VARTRY WATER SUPPLY UPGRADE PROJECT

VARTRY RESERVOIR AND WATER  
TREATMENT PLANT UPGRADE  
Additional Information Response

This report contains detailed responses to the Additional Information Request from the planning authority Wicklow County Council in relation to the proposed development at Vartry Water Treatment Site, Vartry, Roundwood, Co. Wicklow (refer Planning Register Reference 16/363). The responses are summarised below:

**Figure 2-1** Schematic Layout of Vartry Water Treatment Plant

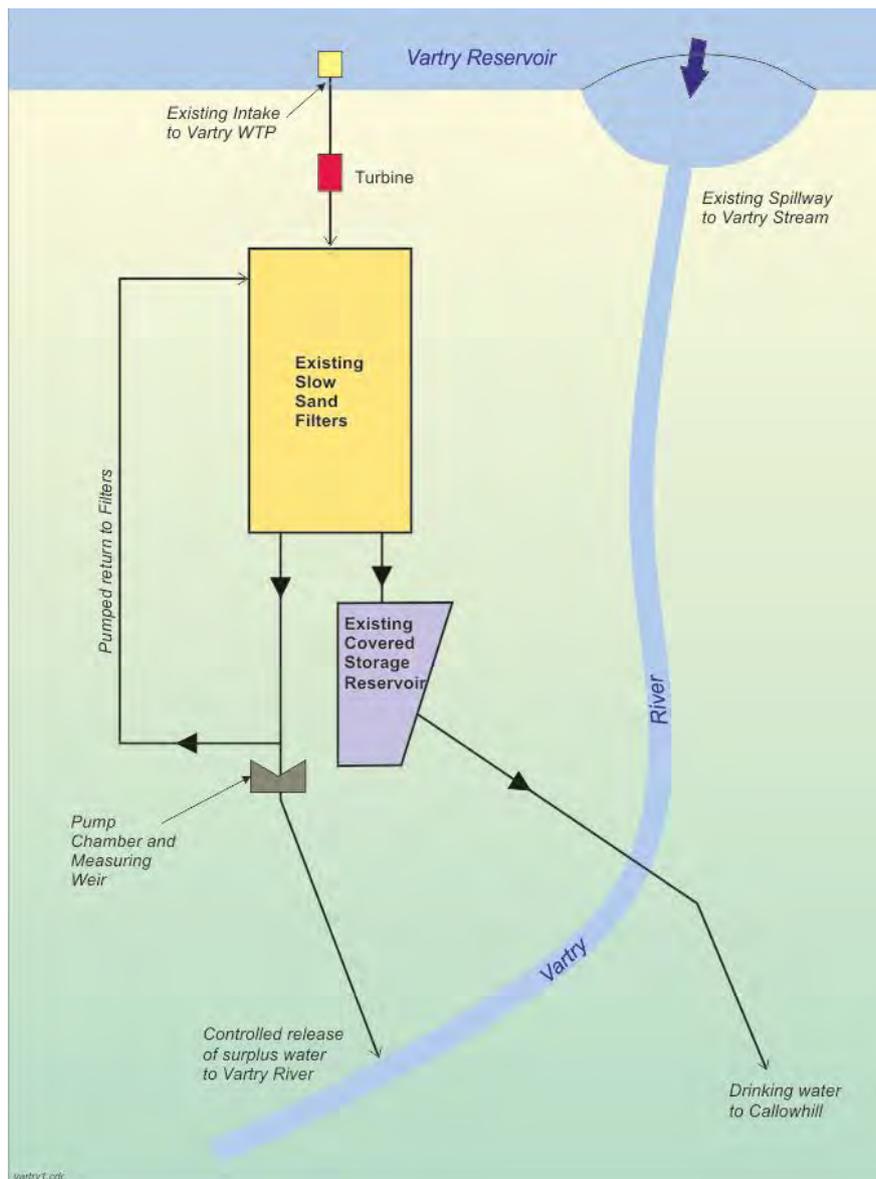
i. *Submit flow readings/estimates for dry weather flow at the discharge location when maximum daily abstractions are occurring at the proposed water treatment plant. This flow figure should take account of any water leaking from old filters, sluices or weirs to the river, after the proposed upgrade. It should also take account*

A simplified schematic layout of the plant is illustrated in Figure 2-1 below.

When the reservoir is not spilling the flow immediately downstream of the plant is predominately made up of releases from the plant. This release consists of water used to drain down and start up filters during the washing cycle and overflows and leakage through the filters. The release of water from the WTP has been recorded at a measuring weir since 1988. A graph illustrating the flow through the weir is presented in Figure 2-2 below.
